534 Delaware Ave., Suite 302  
Buffalo, NY 14202  
May 23, 2018

**Re: Comments on scope and content of the Supplemental Environmental Impact Statement for decommissioning and/or long-term stewardship at the West Valley Demonstration Project and Western New York Nuclear Service Center (DOE/EIS-0226-S1)**

Fig. 2: South Branch of Cattaraugus Creek at about 42.4205°, -78.8806°

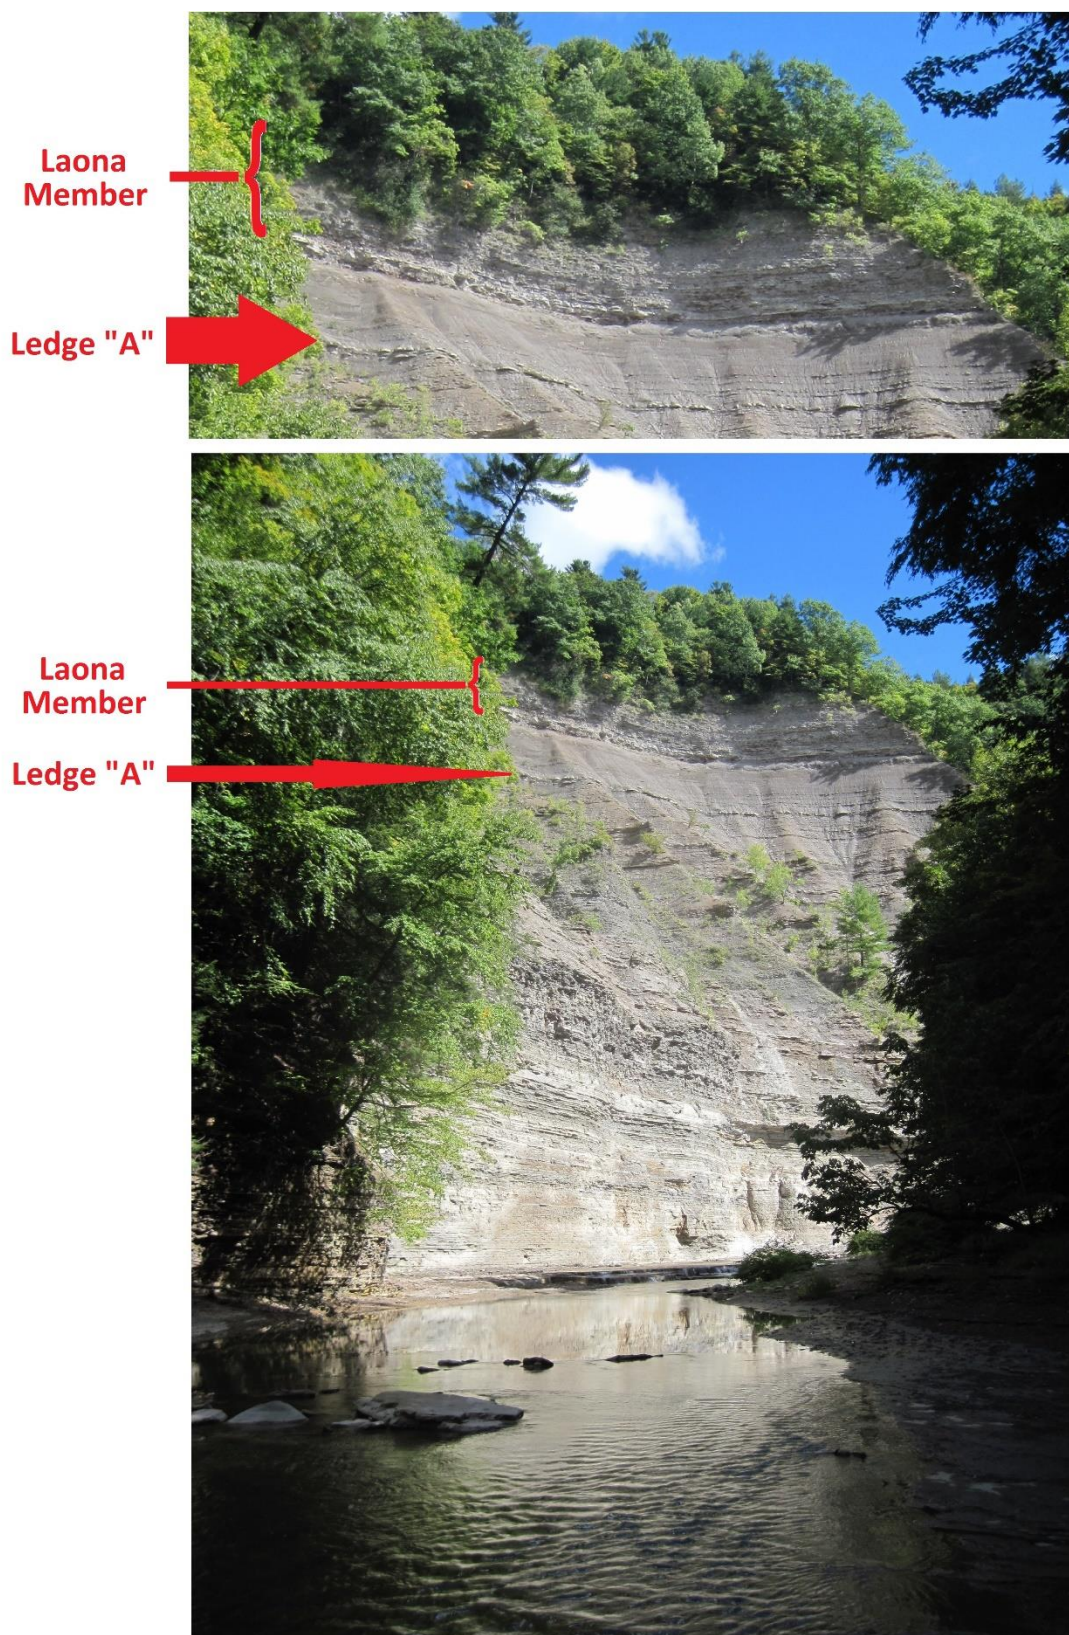
- Ledge “A” can (or recently could) be seen in outcrop along Dutch Hill Rd. south of Edies Rd. (about 42.466°, -78.676°) at about 1470 ft elevation, and also at another nearby location southwest of the Dutch Hill-Edies intersection. This bed is also too high to have been the hypothetical erosion-resistant sill corresponding to an eastward continuation of the strata at ~1274 ft elevation in the Buttermilk Valley
- Ledge “A” also forms the caprock of the waterfall on Quarry Creek west of Rock Springs Rd. (about 42.447°, -78.662°). Again, this bed is too high to have been the hypothetical erosion-resistant sill corresponding to an eastward continuation of the strata at ~1274 ft elevation in the Buttermilk Valley.
